Technical Bulletin

Model(s)	Year(s)	Eng. Code(s)	Trans. Code(s)	VIN Range From	VIN Range To
Touareg, Touareg 2	2007-2009	3.6L (BHK)	All	7L_7D000001	7L_9D017949

01 14 05 February 21, 2014 2019434 Supersedes T.B. V011206 dated March 14, 2012 to correct Technical Diagnosis labor operation coding in the warranty table.

MIL ON, DTCs P0325 or P0327 Stored in ECM Fault Memory

Figure 1

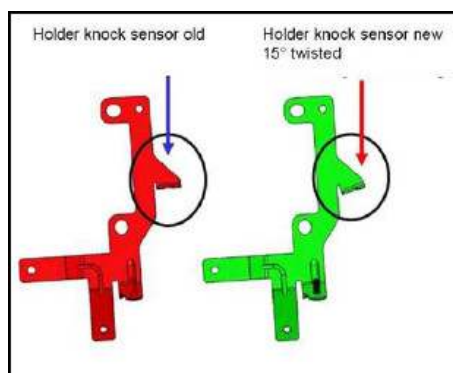
- Inspect whether or not knock sensor bracket Part No. 03H 971 501 D (the new knock sensor bracket that is twisted 15°) is installed.
